Product Safety Recall

25302 Front Wiper Transmission Corrosion Failure (USA Only)

Reference Number: 2025302

Revision: 01

4625477

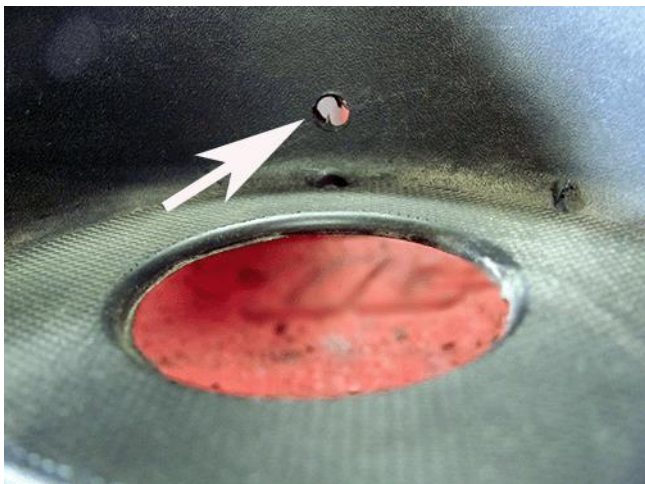
2. With the air inlet panel removed from the vehicle, locate the drain hole by the right side wiper shaft opening.
3. Using a 6mm (15/64 in.) drill bit, enlarge the existing hole to accept the rubber plug.
